Lutz Weber

| Office Action Summary | Application No. 10/527,207 | Applicant(s) WEBER, LUTZ | |

DETAILED ACTION

FIG. 4A

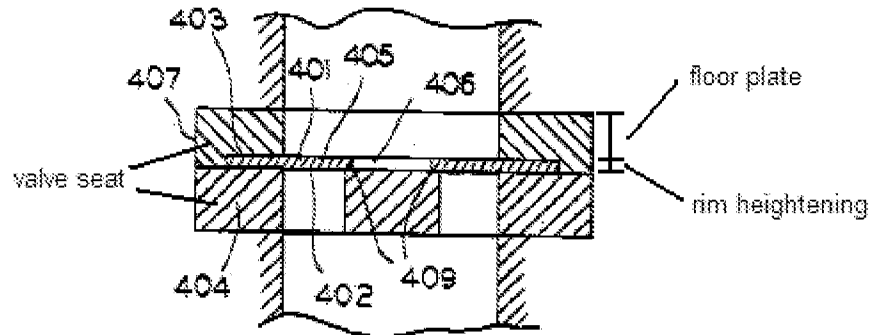
, wherein the valve modules are comprised of a seat component forming the valve seat (valve seat (404) and ring-shaped fixing member (407) in figure 4A) and a spring component forming the valve body (doughnut-shaped disc valve (401)), and wherein the seat component has a recess formed by a rim heightening of a floor plate (The upper portion of the ring shaped fixing member (407) serves as a floor plate upon which the valve rests. The outer rim of the fixing member has a heightened section that forms a recess where the valve can rest, see figure 4A and the labeled image below.), wherein the rim heightening is integrally connected with the floor plate (the heightened

portion is an extension of the rim of the fixing member), and wherein the spring component placed in the recess and located adjacent the rim heightening is centered by the rim heightening (since the rim heightening has the same diameter and height as the valve it would serve to center the valve when the valve is placed inside it), and wherein the spring component is connected with an annular rim portion to the floor plate (an annular rim of the valve is clamped between the floor plate (407) and the valve seat).

FIG. 4A

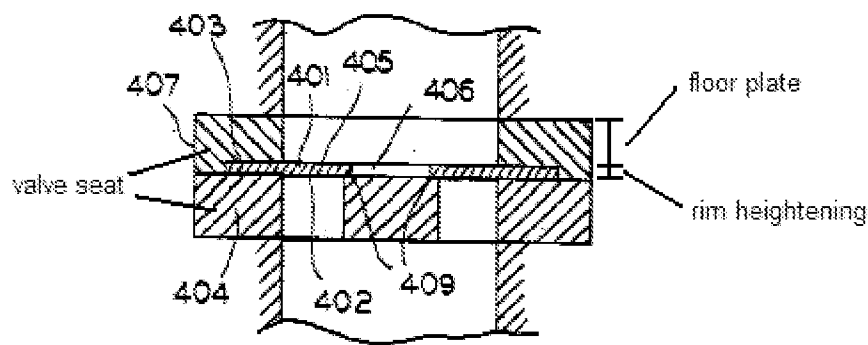
8. Applicant's arguments filed 8/18/08 have been fully considered but they are not persuasive. Applicant argues that the relied upon reference (Suga et al.) does not meet the requirements of claim 1, since it is not automatically centered by a heightened rim area of the valve seat. However, the examiner asserts that, when both the floor plate and the clamping ring are considered to be the valve seat, that the valve seat does have a heightened rim (see the labeled figure below). Furthermore, since both the valve and

the heightened rim have the same diameter and height, when the valve is inserted in the floor plate, the rim portion would automatically center the valve. Thus the apparatus of Suga et al. does meet the requirements of claim 1, and applicant's arguments pertaining to how the valve is attached to the valve seat are moot, since these requirements are not included in the claims.
